MATANUSKA-SUSITNA BOROUGH PLATTING BOARD AGENDA

**SEPTEMBER 3, 2020
REGULAR MEETING
1:00 P.M.**

- *Platting Board Chair to read the Ex-Parte & Interest Memo.*
 - A. **EUREKA TRAILHEAD, LLC:** The request is to divide Lot 1, US Survey 5809 into 33 lots and 1 tract, with interior private roads, to be known as **EUREKA TRAILHEAD ESTATES**, containing 159.96 acres +/- . The petitioner requests a variance from MSB 43.20.300(E)(4)(b) to allow the pole portion of six flag lots to be overlaid with Private Driveway Easements rather than Public Use Easements. The property is located at mile 132 of E. Glenn Hwy. (Tax ID #U05809000L01); lying within Sections 05 & 08, Township 02 North, Range 10 West, Copper River Meridian, Alaska. In Community Council: Glacier View and in Assembly District #1 Tim Hale

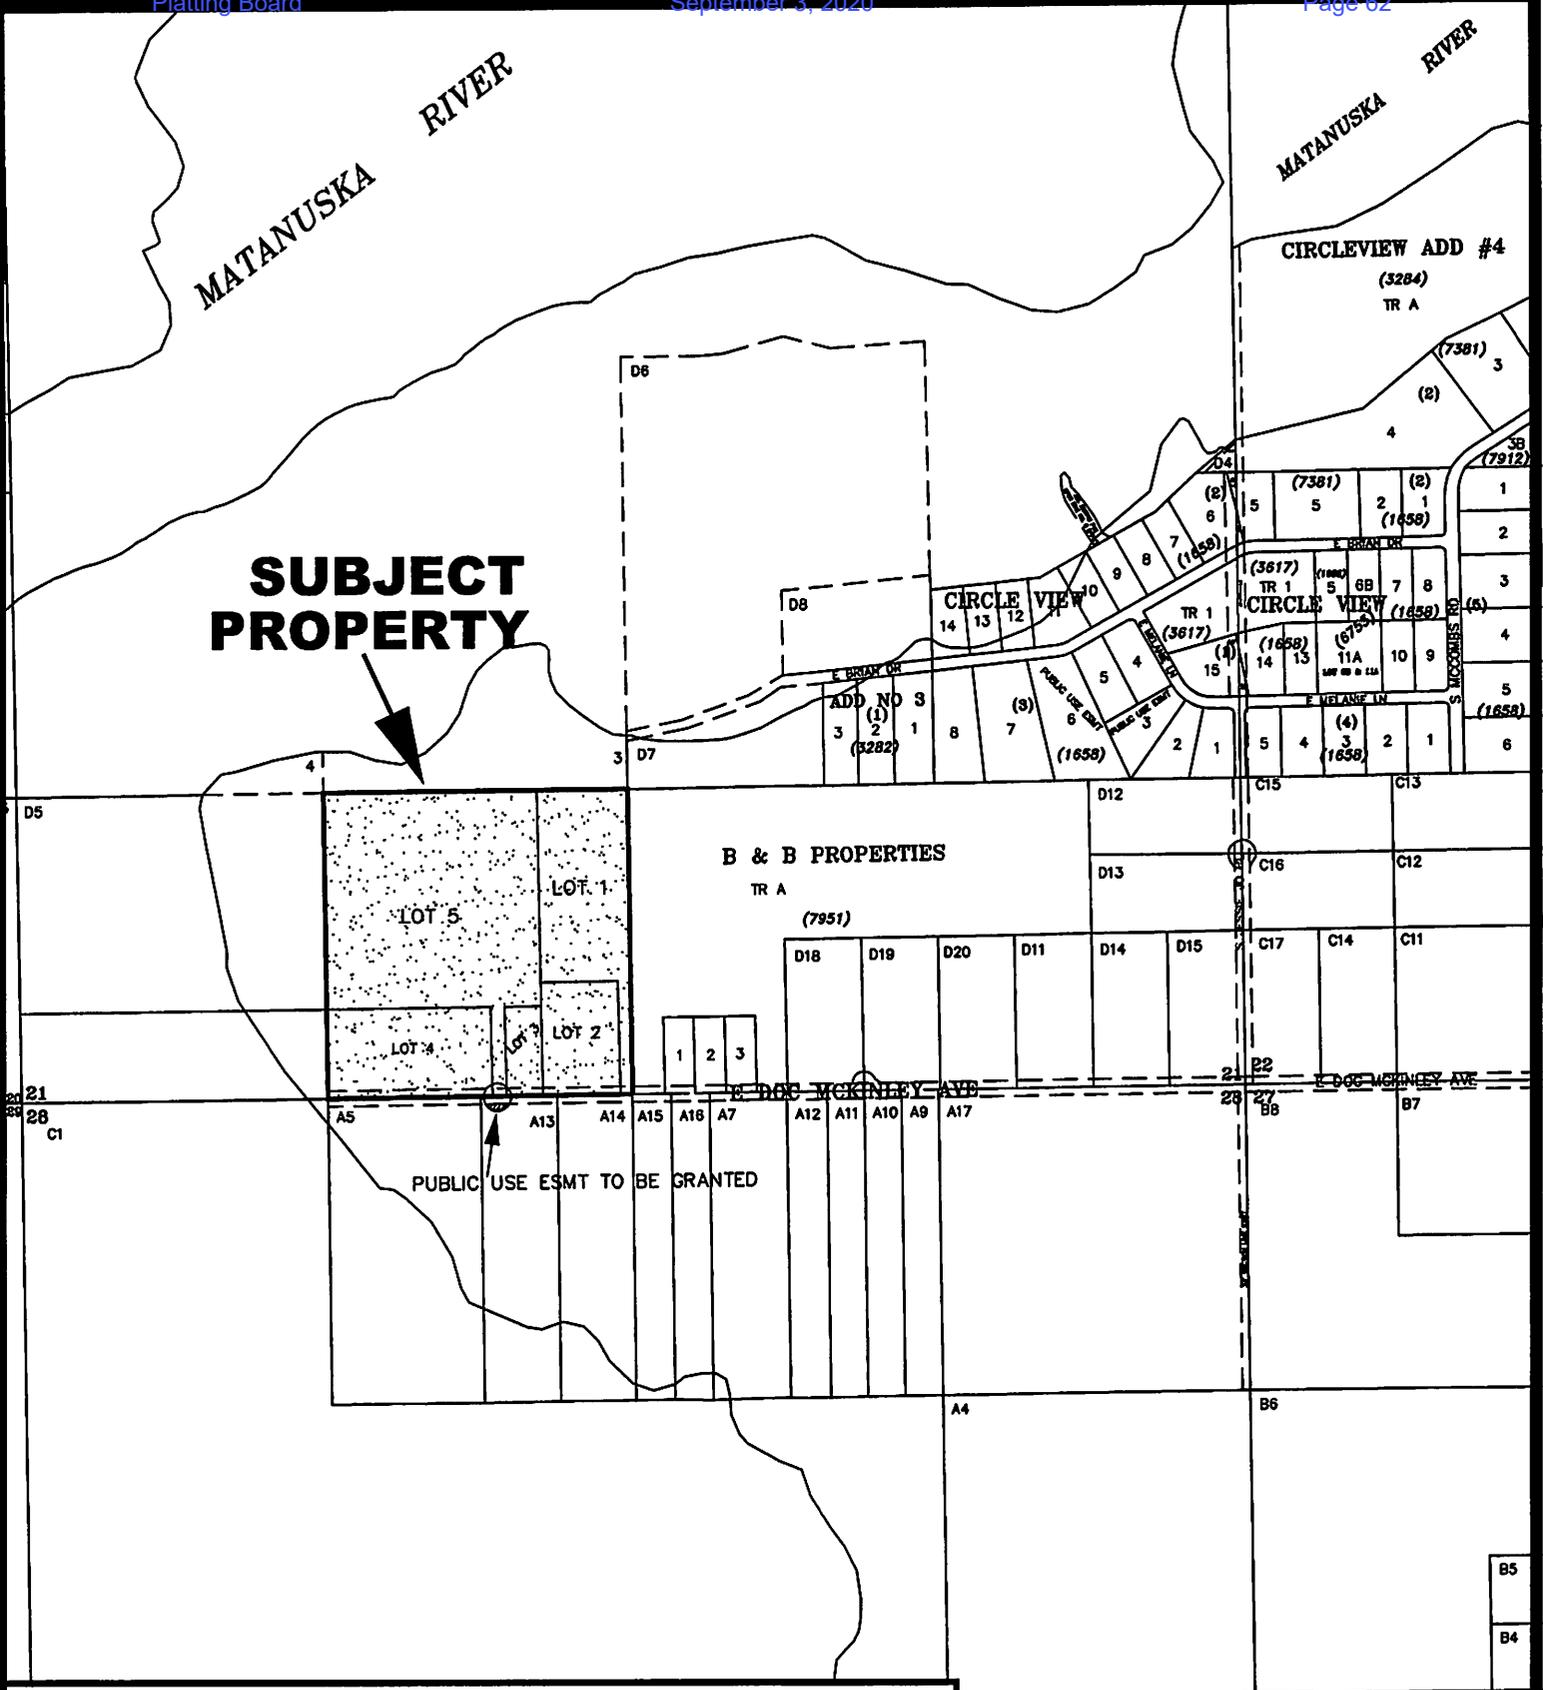
The plat should read Temporary cul-de-sac to be terminated when road is extended. (Remove the 60' because the entire cds cannot be terminated. The portion created by document would require a vacation)

The exhibit legal needs the word temporary removed. We do not create temporary PUE's.
